Change Summary: Board reconfigured for single 10 Hz pole.

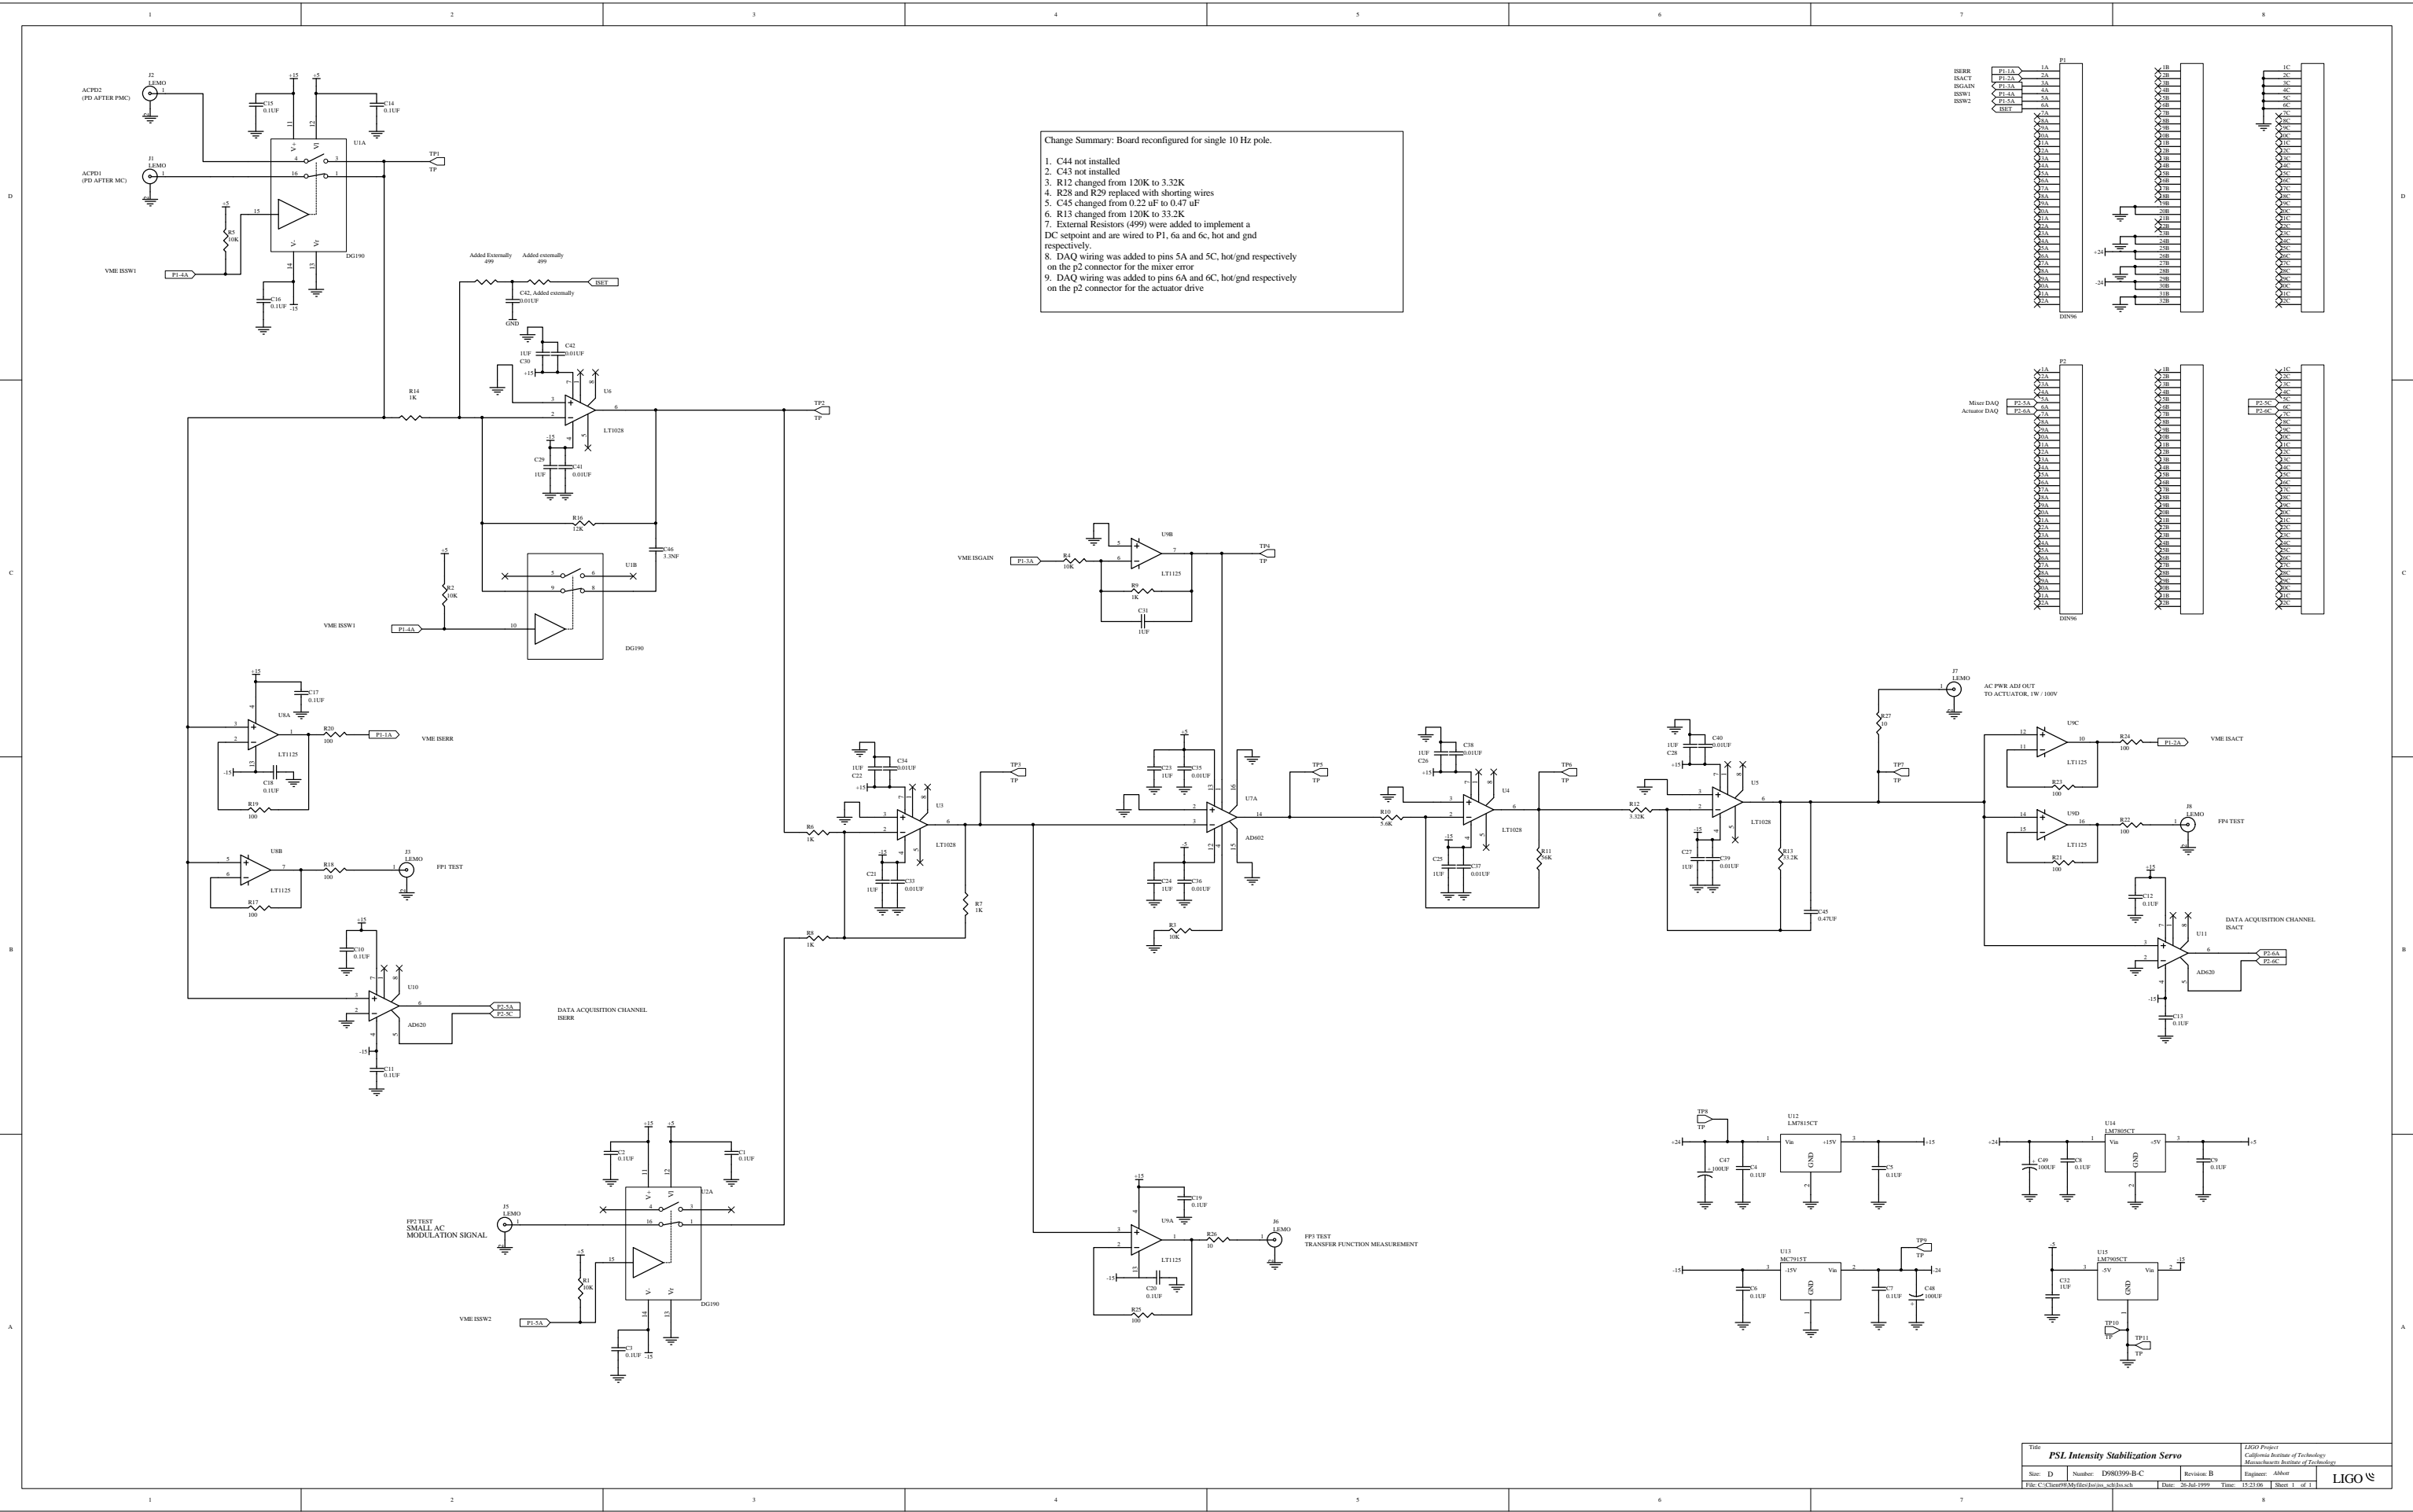
1. C44 not installed
2. C43 not installed
3. R12 changed from 120K to 3.32K
4. R28 and R29 replaced with shorting wires
5. C45 changed from 0.22 uF to 0.47 uF
6. R13 changed from 120K to 33.2K
7. External Resistors (499) were added to implement a DC setpoint and are wired to P1. 6a and 6c, hot and gnd respectively.
8. DAQ wiring was added to pins 5A and 5C, hot/gnd respectively on the p2 connector for the mixer error
9. DAQ wiring was added to pins 6A and 6C, hot/gnd respectively on the p2 connector for the actuator drive
